Access Compliance Report

(Curb Ramps)

Intersection ID: 44272	Main Street: TRAVIS_FLOYD_LN	Cross Street: DANIEL_DWAYNE_DR	Location:	N
ADA ID: 5B99D0B54098	Ramp Type: PerpDiag	Initial Pass/Fail: Fail	Overall Compliance: No	Severity Score: 22.5
Codes/Mitigation Info/Possible Solution		Field Measurements/Component Compliance

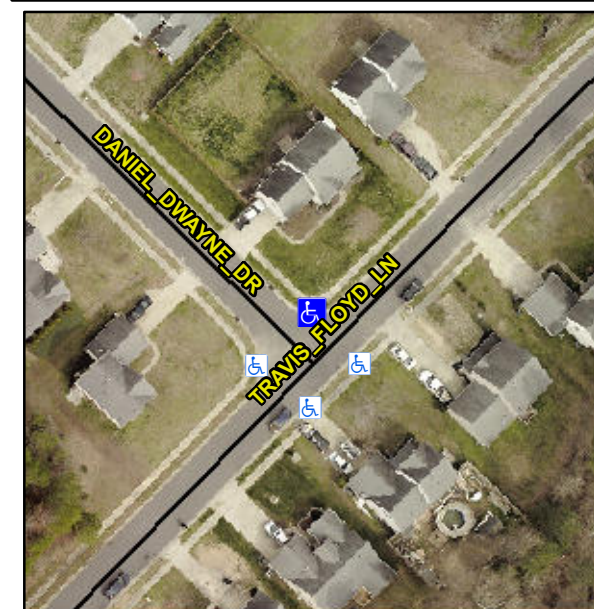
Not Found, R304.5.1, R304.2.2, R304.5.3

Compliance	Description	Data	Compliance	Description	Data
N/A	Ramp Length (in)	46.0	No	Ramp Slope (%)	10.0
No	Ramp Width (in)	36.0	No	Ramp XSlope (%)	2.8
N/A	Flare Type LT	N/A	N/A	Flare Type RT	N/A
N/A	Flare Slope LT (%)	N/A	N/A	Flare Slope RT (%)	N/A
N/A	Flare Traversable LT?	N/A	N/A	Flare Traversable RT?	N/A
N/A	Landing Length (in)	N/A	N/A	DWS Provided?	N/A
N/A	Landing Width (in)	N/A	N/A	DWS Contrast?	N/A
N/A	Landing Slope (%)	N/A	N/A	DWS Length (in)	N/A
N/A	Landing X Slope (%)	N/A	N/A	DWS Full Width?	N/A
N/A	Landing Curb? (Y/N)	N/A	N/A	DWS Offset (in)	N/A
N/A	Shared Landing?	N/A			
N/A	Gutter Ponding?	N/A	N/A	Gutter Slope (%)	N/A
N/A	Gutter Lip Ht (in)	N/A	N/A	Gutter X Slope (%)	N/A
N/A	Painted X Walk1?	No	N/A	Painted X Walk2?	No
	X Walk 1 Direction	To W		X Walk 2 Direction	To E
N/A	X Walk 1 Width (in)	N/A	N/A	X Walk 2 Width (in)	N/A
	X Walk 1 Slope (%)	5.9		X Walk 2 Slope (%)	4.8
	X Walk 1 X Slope (%)	1.8		X Walk 2 X Slope (%)	2.4

Remove & Replace Curb Ramp With Two New Directional Ramps or Equivalent.
